Determination 2006/91

Surface water requirements for a building at 311 Annandale Road, RD2, Henderson

Figure 1: Wall adjacent the water tank

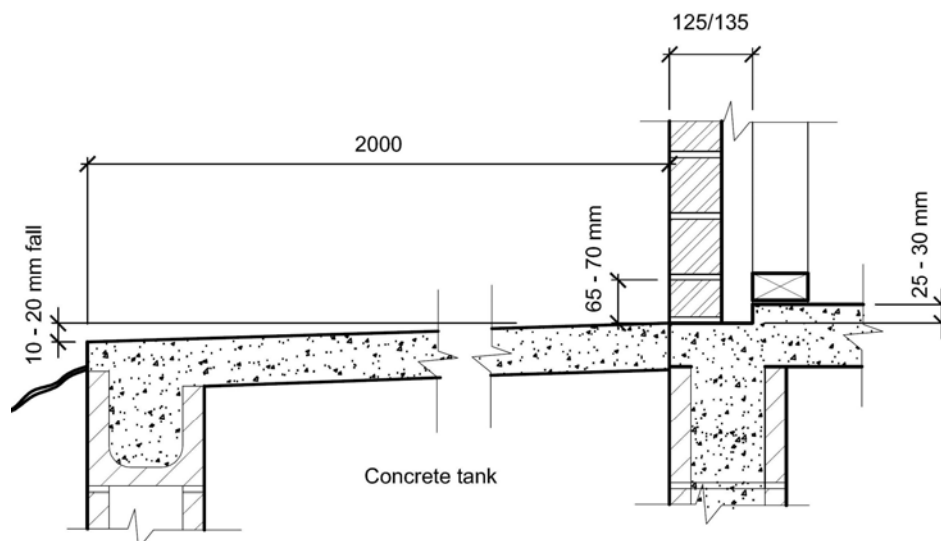
- (a) In the water tank area, the bottom course of the blockwork is set above the paving, resulting in an up-stand varying from approximately 25mm to 30mm high to the interior floor level: refer Figure 1.

- There is no gap between the bottom edge of the fibre-cement weatherboards and the concrete of the northeast garage porch.
- 5.5 The expert noted that, while the set-down of the veranda paving below the interior floor level is only 25-30mm at the water tank area, the paving to wall junction is sheltered under a 2.4m roof overhang.

6.4 I accept that the floor separation and clearance provided at the water tank area (Figure 1) is adequate in the circumstances, as the junction is sheltered beneath a 2.4m deep veranda roof and the concrete paving falls away from the house.

Figure 2: Wall generally adjacent the concrete veranda

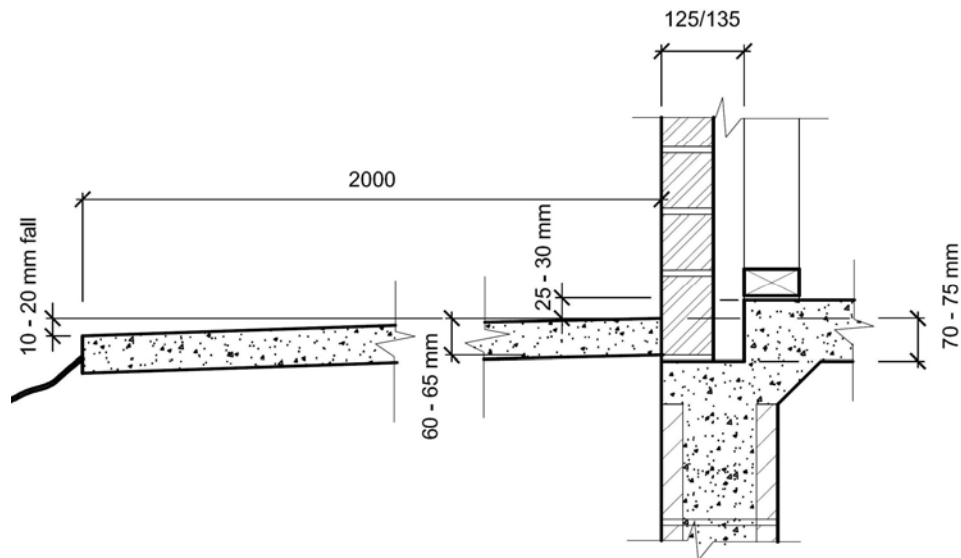
- (b) Elsewhere the veranda paving has been installed after the erection of the block veneer, with the concrete paving poured against the block veneer resulting in the creation of a 70-75mm deep x 40mm wide channel between the block veneer and the rebate in the house floor slab at the bottom of the block veneer cavity: refer Figure 2.

- 5.4 The expert made the following specific comments on the cladding:
- Water is able to enter the blockwork cavity via the open perpend in the blockwork and will be trapped in the channel formed by the blockwork and the rebate to the floor slab (refer Figure 2).

6.5 The expert noted that the cavity at the base of the block veneer adjacent to the general veranda paving (Figure 2) can retain water entering from the exterior through the blockwork via the open perpends. The base of the wall cavity is below the top surface of the paving, creating an un-drained channel in the cavity 70mm to 75mm deep. Any water trapped in the channel may lead to elevated levels of moisture in the bottom plate and adjacent framing.

reaching the junction, however, there is very limited protection provided by the veranda in two locations (southern elevation at either end of the garage). Additionally, I consider that water is likely to enter the cavity as a result of normal maintenance and cleaning activities involving water, and in two areas where the lower wall may be exposed to rain, whether wind-driven or otherwise. Any water entering the cavity will be unable to drain away, which may lead to undue dampness within the cavity itself.

- 7.2 I consider that the drainage of the blockwork cavity is an essential element of what is intended to be a drained cavity system. At present this is compromised by the presence of what is effectively a non-draining channel between the blockwork and the rebate in the concrete floor slab. In particular, I am concerned that there is no apparent provision for any water entering the cavity to be able to freely drain away.

- 6.7 I also consider that, if a satisfactory method of draining the cavity is proposed, to the approval of the territorial authority, the clearances between the interior floor level and the veranda concrete will be adequate in these circumstances.

- 8.2 However, I am able to conclude that satisfactory rectification of the faults outlined in paragraph 5.4 will result in the building becoming code compliant.
- 8.3 I would suggest that the parties adopt the following process to meet the requirements of paragraph 8.2. Initially, the territorial authority should withdraw the notice to fix dated 12 May 2006 and issue a new notice to fix, requiring the owners to bring the house into compliance with the Building Code. The notice to fix may list the items to be rectified but it should not specify how compliance is to be achieved as this is for the owner to propose and for the territorial authority to accept or reject. It is important to note that the Building Code allows for more than one method of achieving compliance.
